SERVICE BULLETIN

DATE: 6 MAY 2003

CABIN FLOOR ATTACH POINTS INSPECTION AND REWORK

Figure 1. Installation of Doublers

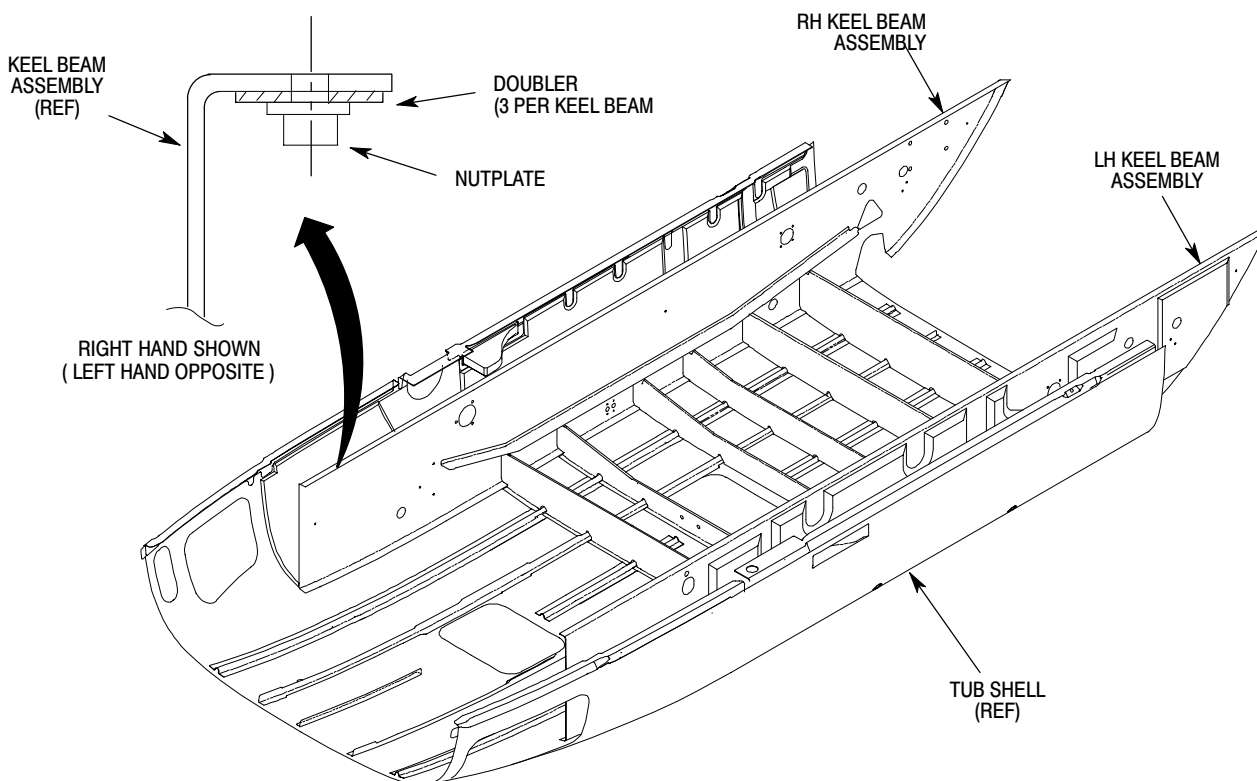
There have been reports of deformation and delamination of the composite material in the area of the center cabin floor attach holes in the left and right keel beams.

Procedures in this Bulletin provide owners and operators with information pertaining to inspecting the left and right keel beams and if required, adding doublers on the lower surface of the left-hand and right-hand upper keel beam flanges.

- (11). Prepare doublers for bonding.
 - (a). Wipe doublers with wiper dampened with solvent cleaner or isopropyl alcohol.
 - (b). Wipe dry with clean, dry wiper and air dry for 15 minutes at ambient temperature.
 (Ref. Figure 1)

- (12). Bond doublers in place on lower surface of upper flange of left-hand and right-hand keel beams.
 - (a). Use cleco fasteners to align nutplate rivet holes and secure doublers during bonding.

- (b). Bond doublers with epoxy adhesive per manufacturer's instructions.
 - (c). Perform coin tap inspection on all doublers, no voids allowed (Ref. CSP-SPM, Section 20-90-00, Coin Tap Inspection).

- (13). Install new nutplates with rivets through keel beam flange and doublers. Install rivets wet with epoxy primer.
